STERLING RANCH FILING NO. 2

FINAL PLAT
STERLING RANCH FILING NO. 2
JOB NO. 25188.01
01/21/2021
SHEET 1 OF 7

FILE NO. SF-20-015

plat V_2 planning only.pdf Markup Summary 3-26-2021

FINAL PLAT
STERLING RANCH FILING NO. 2
JOB NO. 25188.01
01/21/2021
SHEET 5 OF 7
FILE NO. SF-20-015

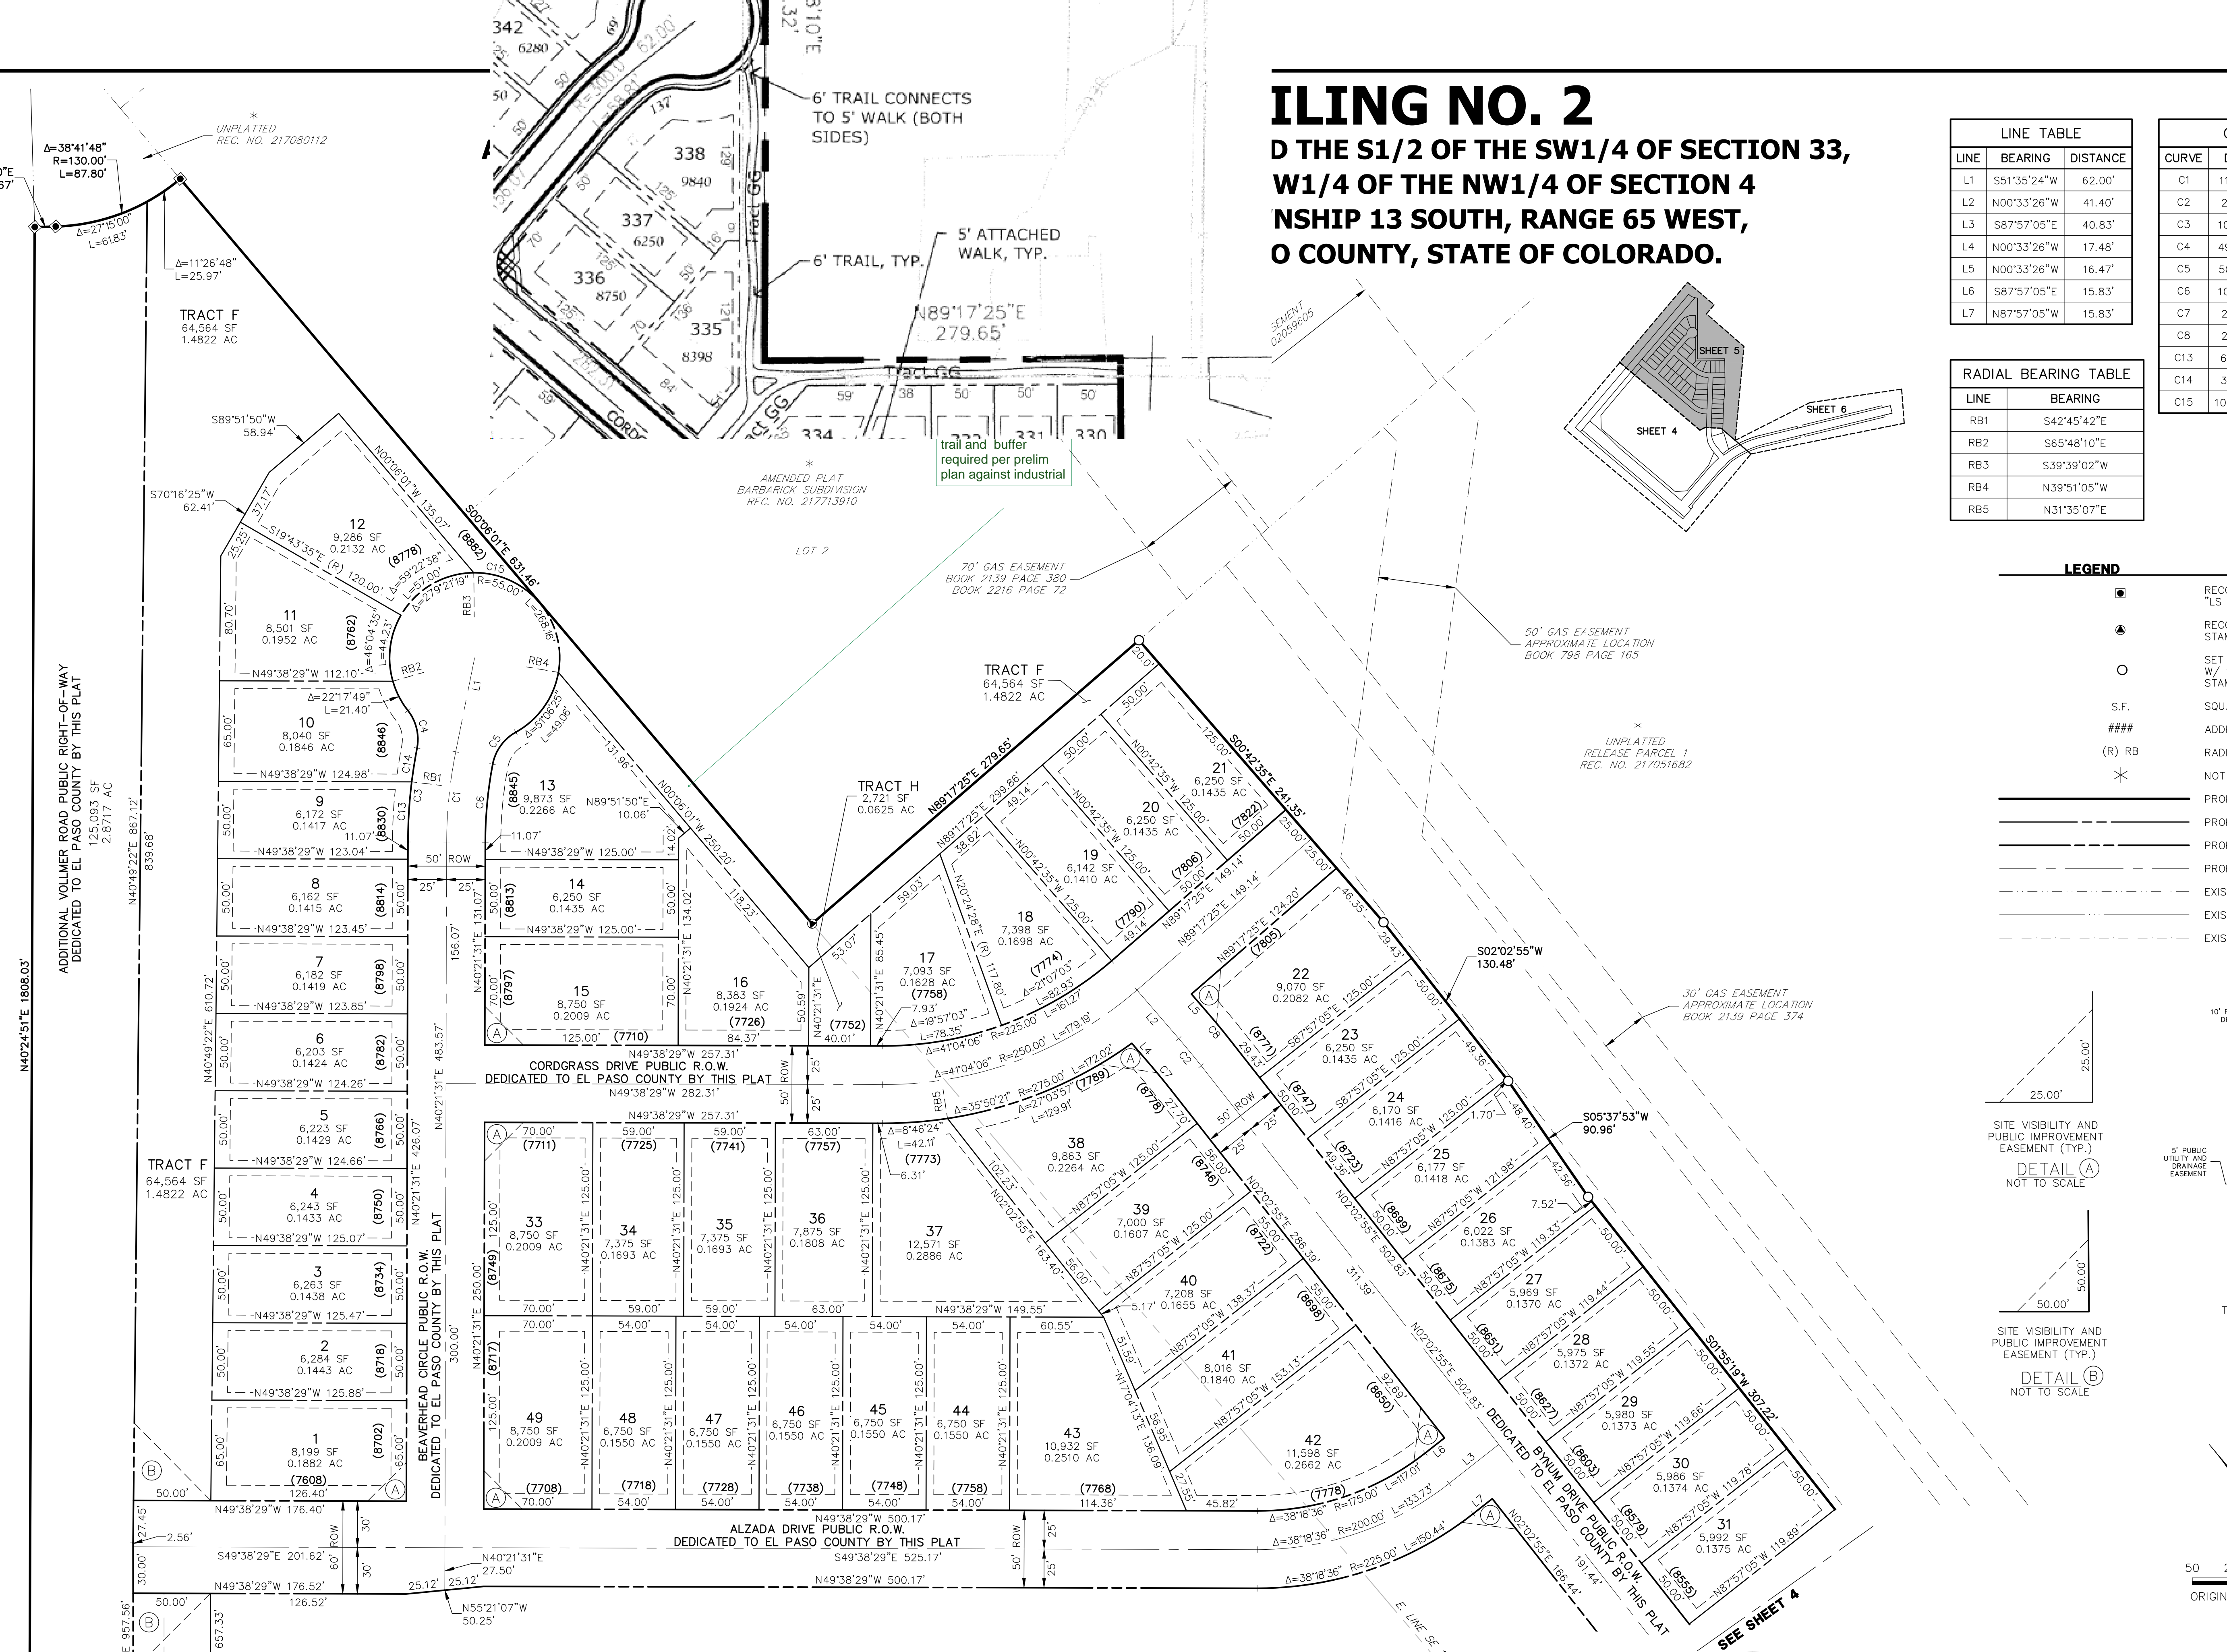
trail and buffer required per prelim plan against industrial
